Norwest Marketown Planning Proposal

LPP Response Urban Design Package — 24/05/23

Local Planning Panel Advice

Figure 79. Illustrative Ground Floor Plan

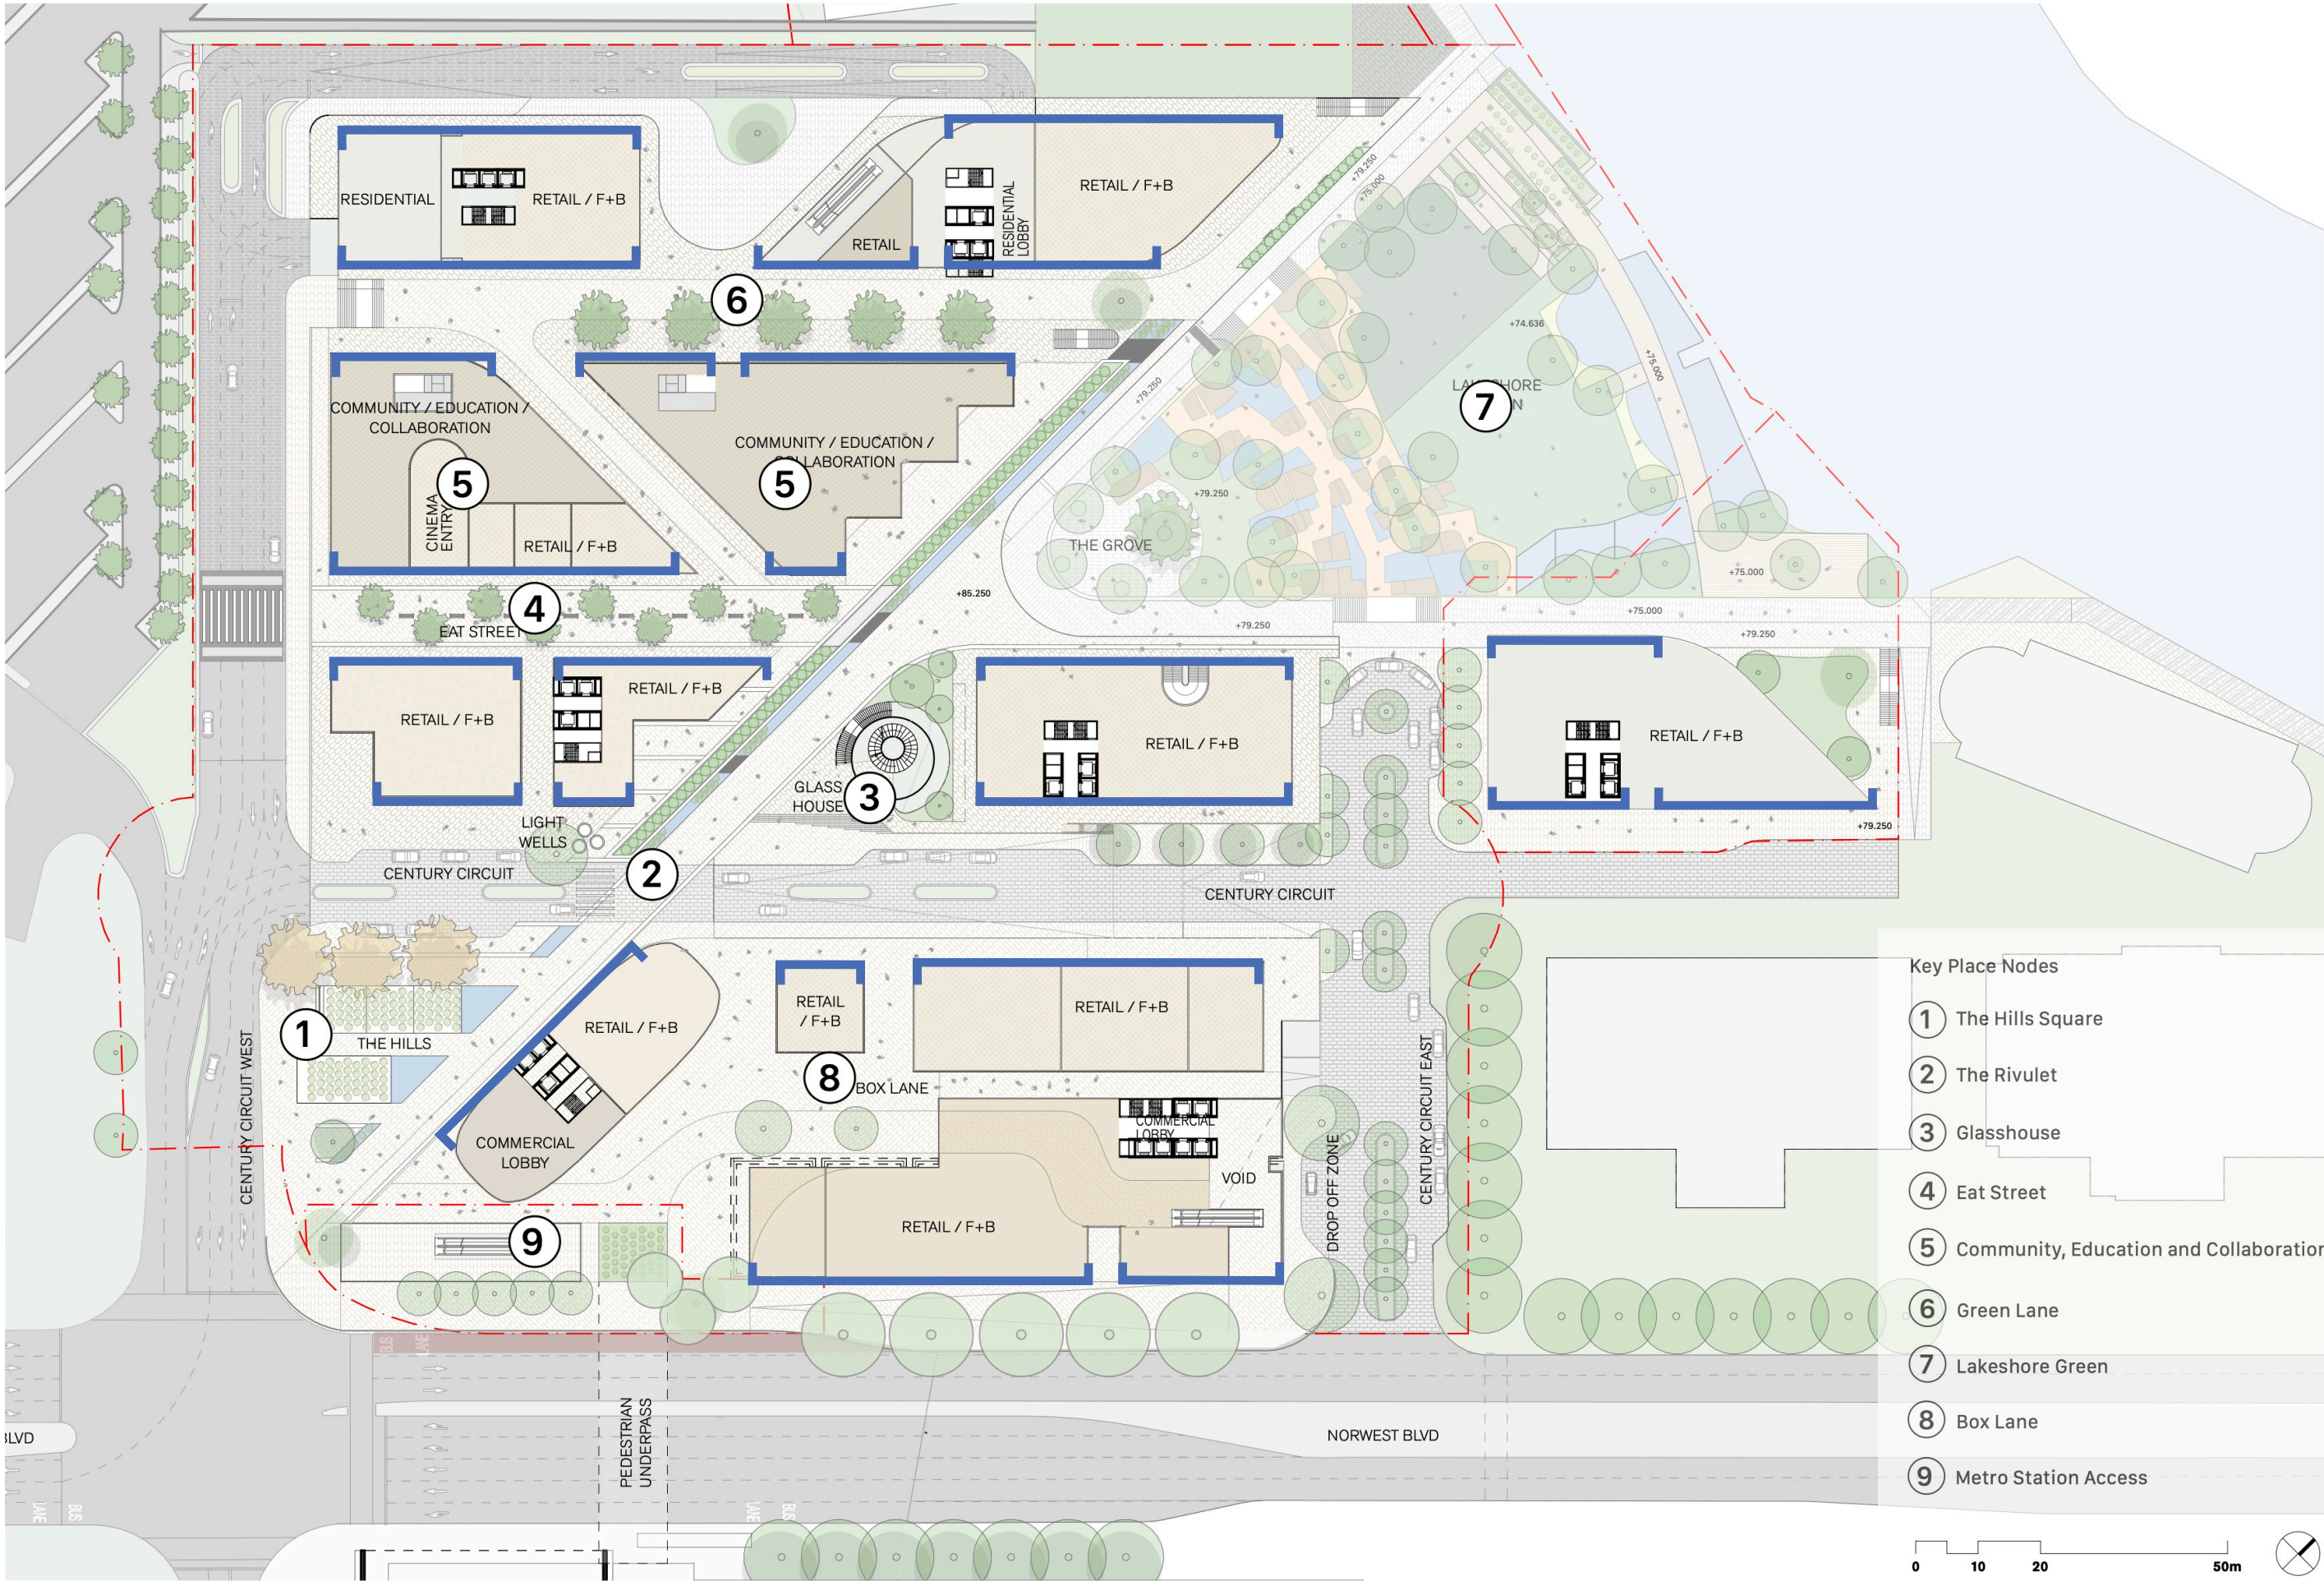
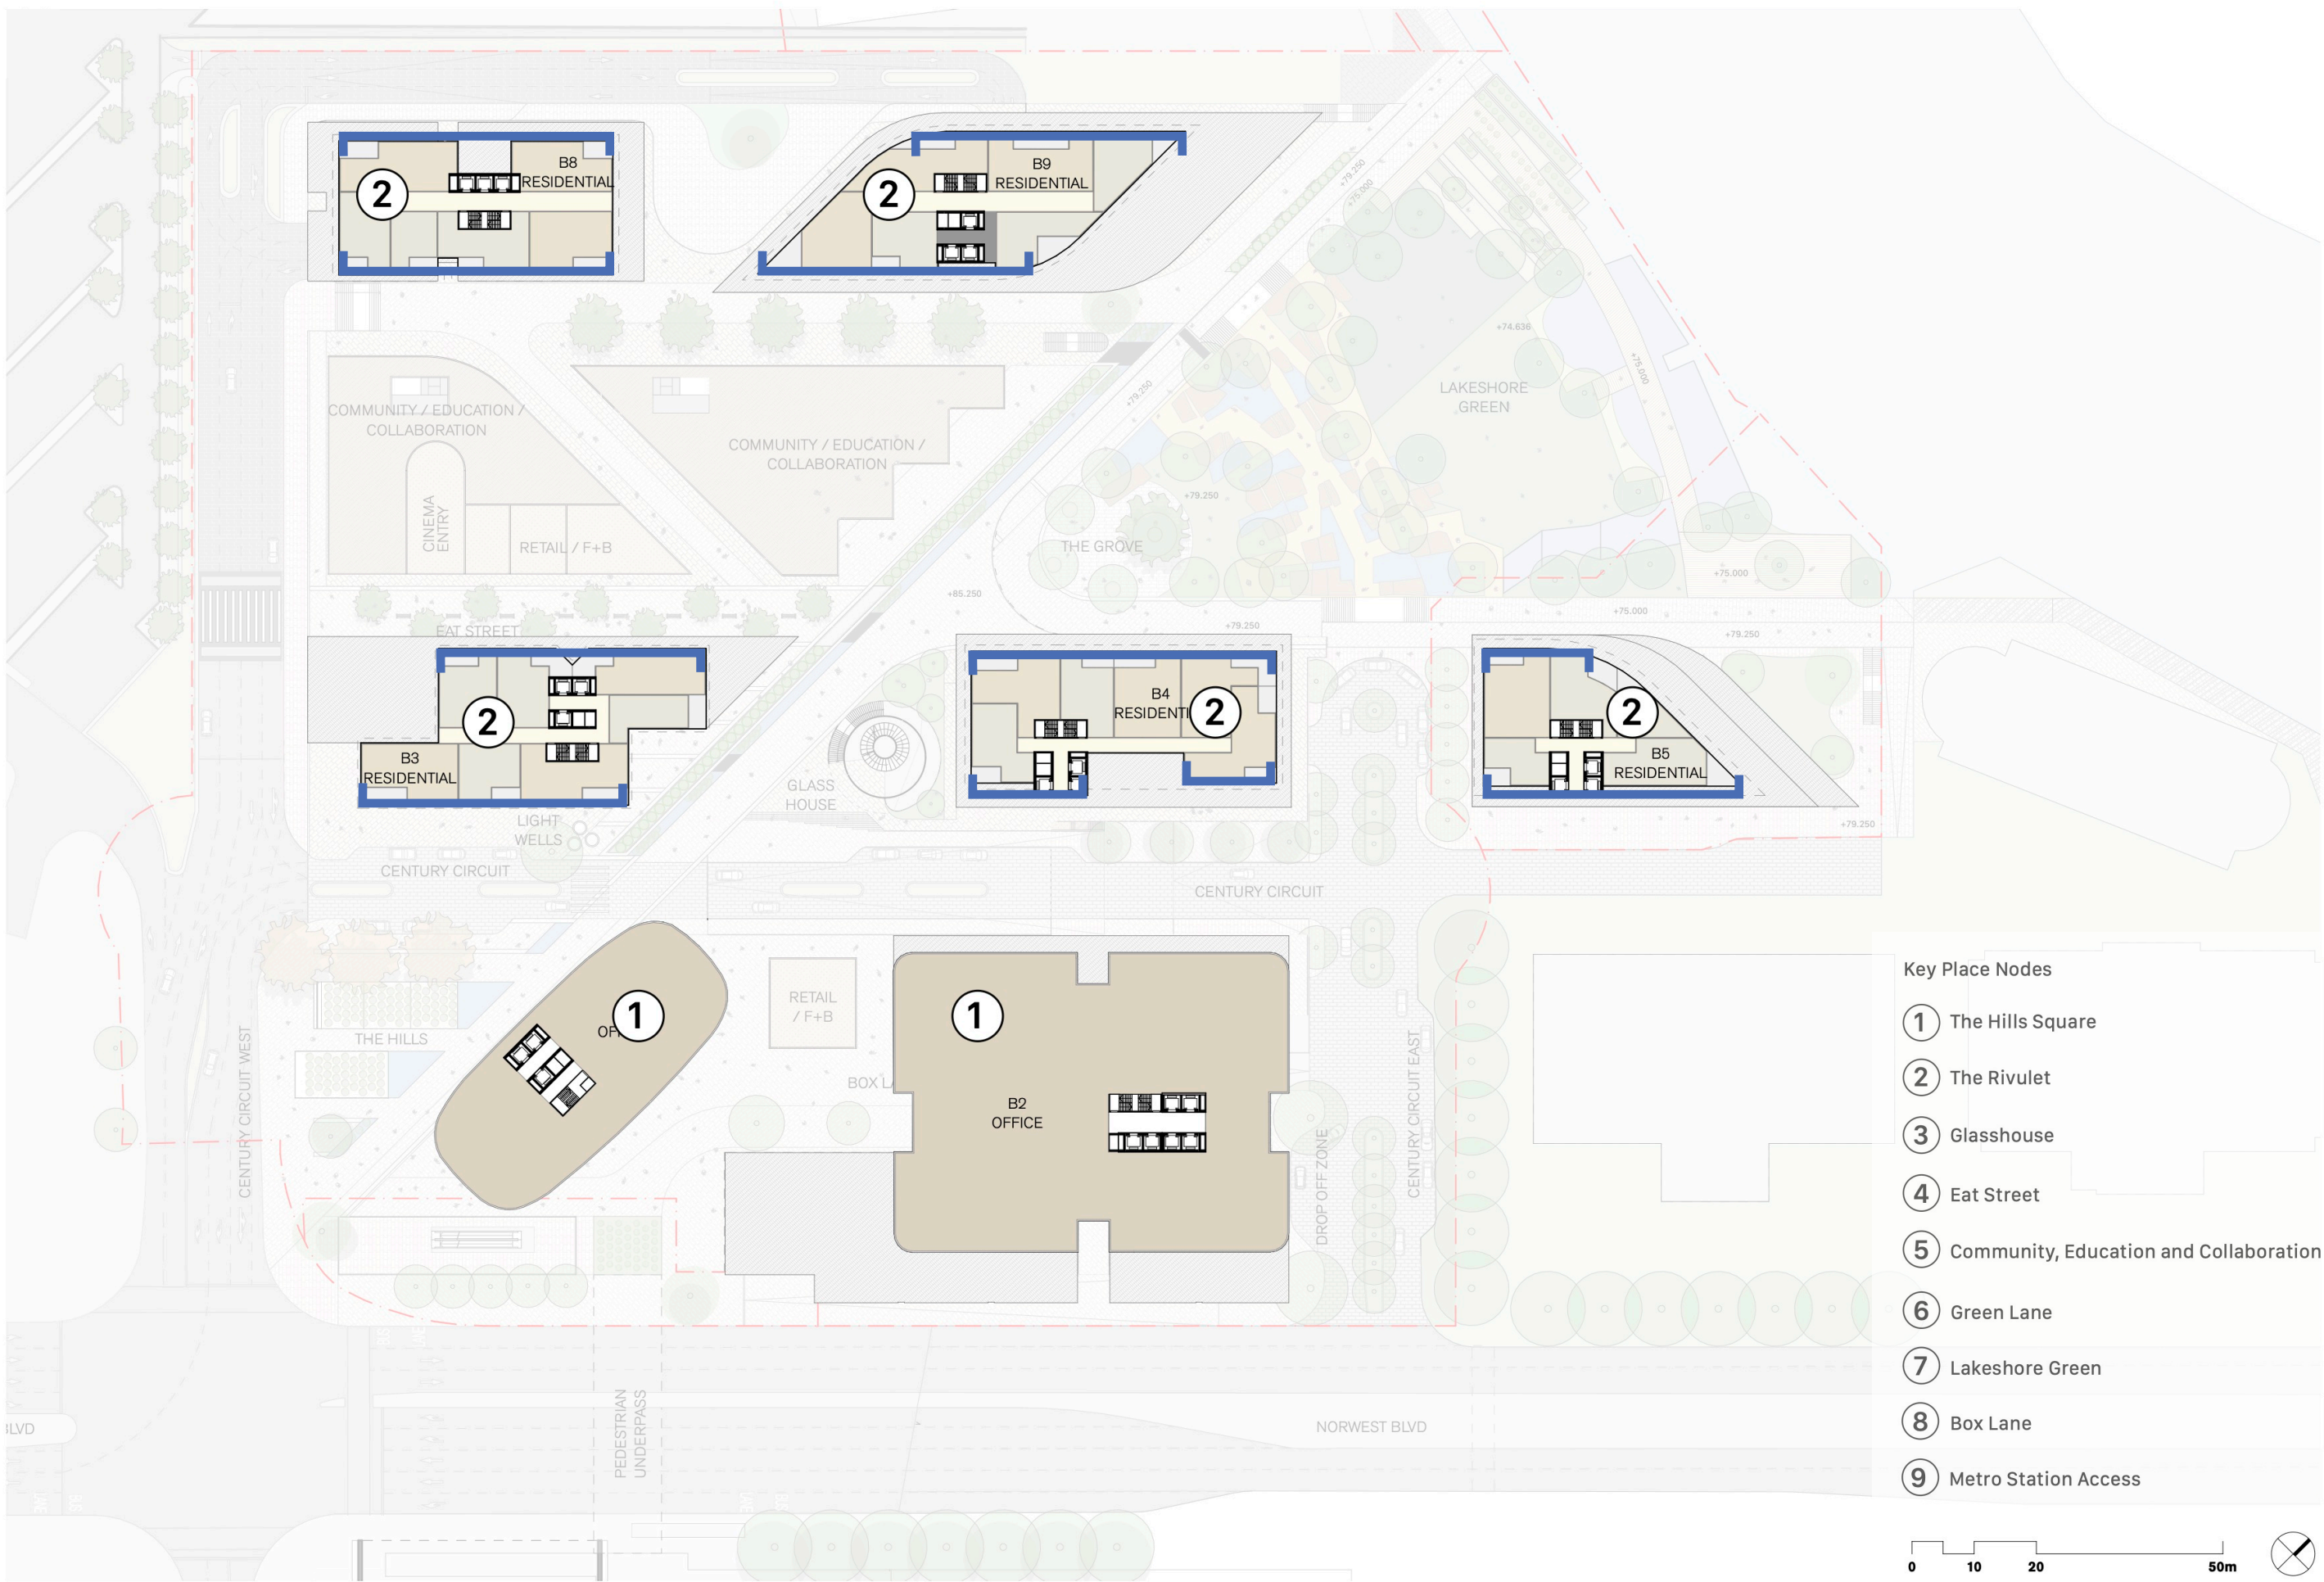
Maximum podium length of 65 metres
(rather than 84 metres);

Norwest Marketown is underpinned by a focus on public domain and streetscape outcomes. Scaled and articulated podiums are fully supported and able to be achieved.

The diagram opposite indicates potential podium facades with breaks representing articulation, arcades, building entries and laneway connections. The maximum continuous podium length will be 65m.

65m maximum
podium length

Figure 81. Illustrative Typical Apartment Level Plan

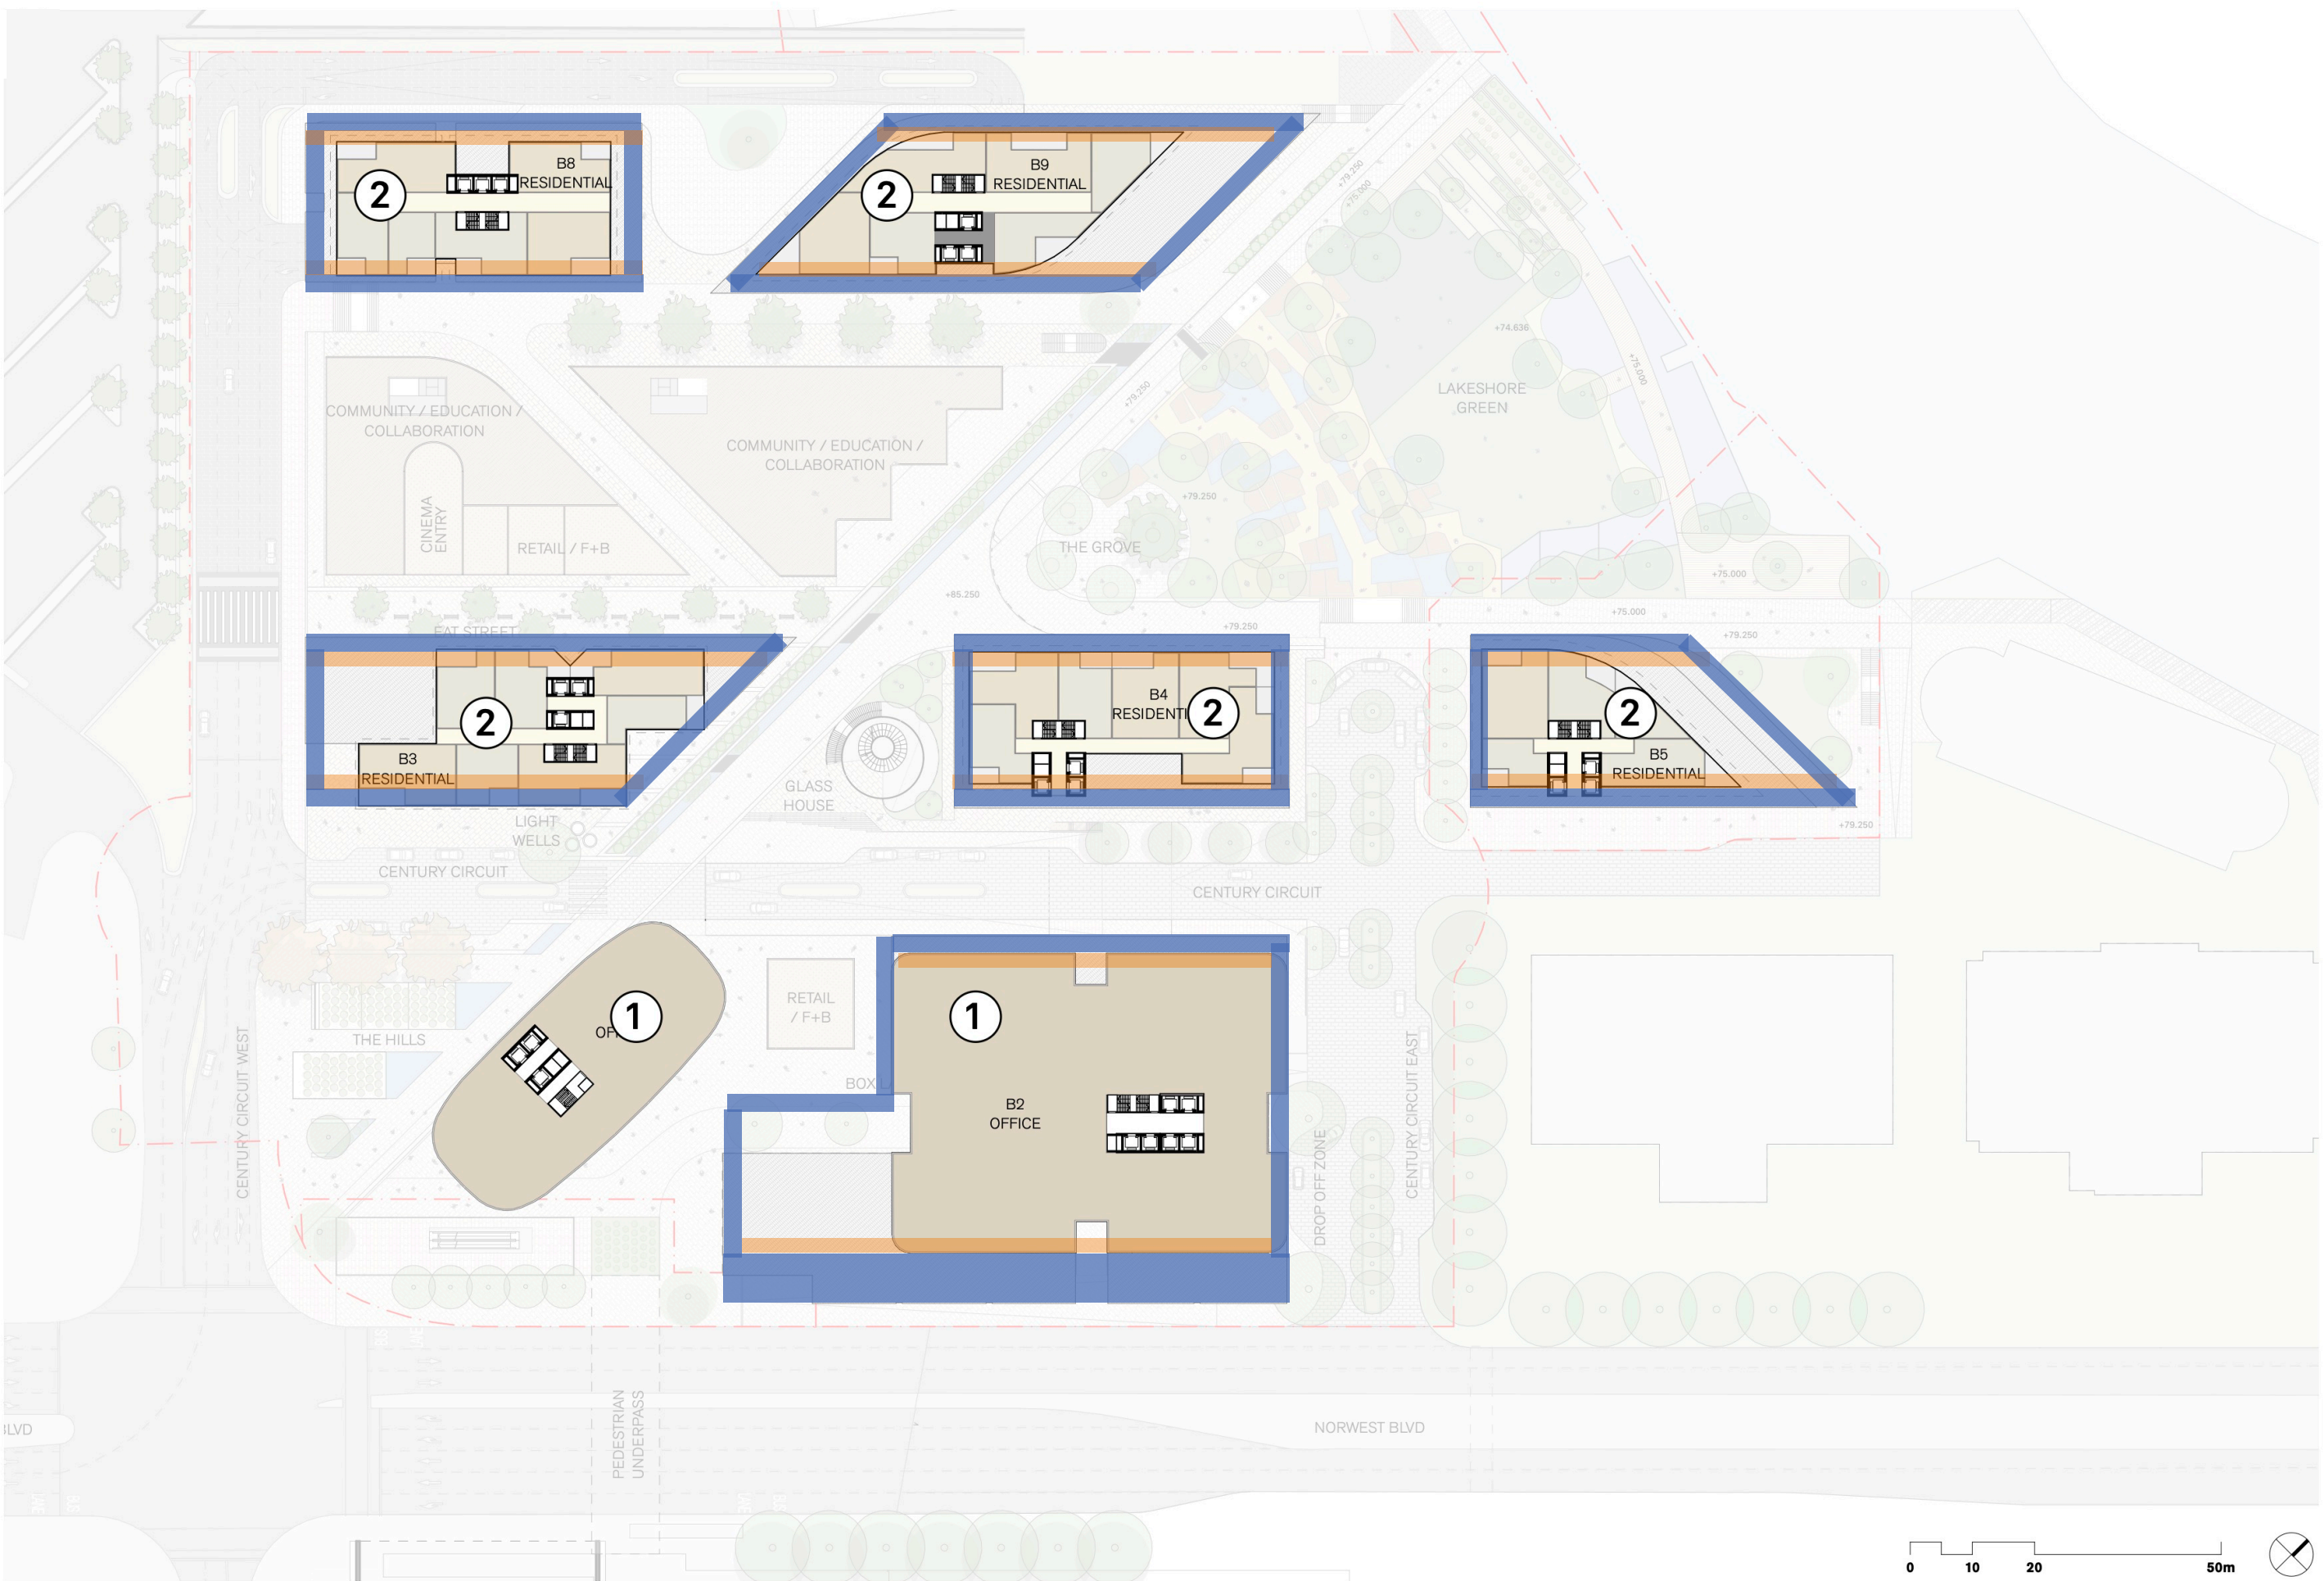
Minimum tower setbacks above podium of 5 metres (rather than 1.5 metres);

The built form arrangement for Norwest Marketown:

- develops clear podium or streetwall buildings
- creates inset and active levels above podium
- sets back tower forms
- proposes articulated facades with opportunities for integrated landscape

A minimum tower setback of 3m is proposed for residential or mixed use buildings. An additional 2m waistline setback to the floor directly above the podium level is also proposed to the long frontage of each building.

This approach balances built form articulation with maximisation of the open space and public domain areas.

Specific podium and setback controls are not proposed to be defined for the landmark commercial tower. The form, scale and wind mitigation of this building form will be developed through a design excellence competition process.

- 3m minimum setback
- 2m waistline setback
